# Access Compliance Report

## Public Rights-of-Way

### (Curb Ramps)

Intersection ID: N/A	Main Street: STYLE_LN	Cross Street: OUTLETS_BV	Location: NW
ADA ID: A714D2377873	Ramp Type: PerpDiag	Initial Pass/Fail: Fail	Overall Compliance: No
Severity Score: 58.75			
Codes/Mitigation Info/Possible Solution		Field Measurements/Component Compliance

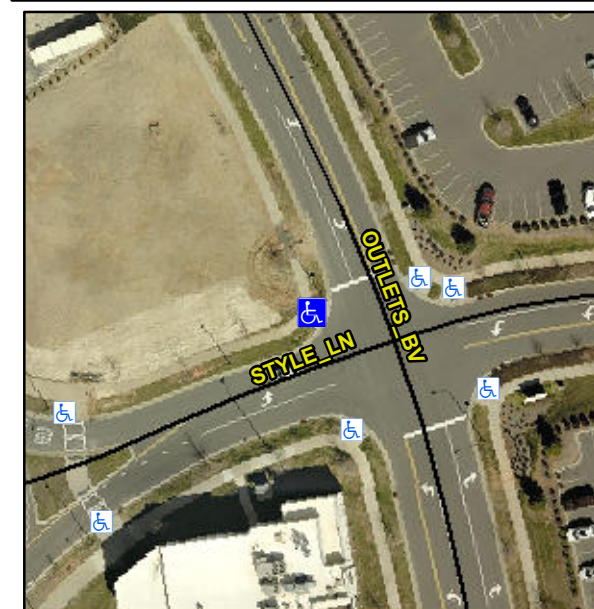
**Not Found, R304.5.1, R304.2.2, R304.5.3**

Compliance	Description	Data	Compliance	Description	Data
N/A	Ramp Length (in)	96.0	No	Ramp Slope (%)	12.1
No	Ramp Width (in)	42.0	No	Ramp XSlope (%)	8.7
N/A	Flare Type LT	N/A	N/A	Flare Type RT	N/A
N/A	Flare Slope LT (%)	N/A	N/A	Flare Slope RT (%)	N/A
N/A	Flare Traversable LT?	N/A	N/A	Flare Traversable RT?	N/A
N/A	Landing Length (in)	N/A	N/A	DWS Provided?	N/A
N/A	Landing Width (in)	N/A	N/A	DWS Contrast?	N/A
N/A	Landing Slope (%)	N/A	N/A	DWS Length (in)	N/A
N/A	Landing X Slope (%)	N/A	N/A	DWS Full Width?	N/A
N/A	Landing Curb? (Y/N)	N/A	N/A	DWS Offset (in)	N/A
N/A	Shared Landing?	N/A			
N/A	Gutter Ponding?	N/A	N/A	Gutter Slope (%)	N/A
N/A	Gutter Lip Ht (in)	N/A	N/A	Gutter X Slope (%)	N/A
N/A	Painted X Walk1?	No	N/A	Painted X Walk2?	No
	X Walk 1 Direction	To S		X Walk 2 Direction	To E
N/A	X Walk 1 Width (in)	N/A	N/A	X Walk 2 Width (in)	N/A
	X Walk 1 Slope (%)	0.7		X Walk 2 Slope (%)	5.5
	X Walk 1 X Slope (%)	3.7		X Walk 2 X Slope (%)	2.6

**Remove & Replace Curb Ramp With Two New Directional Ramps or Equivalent.**
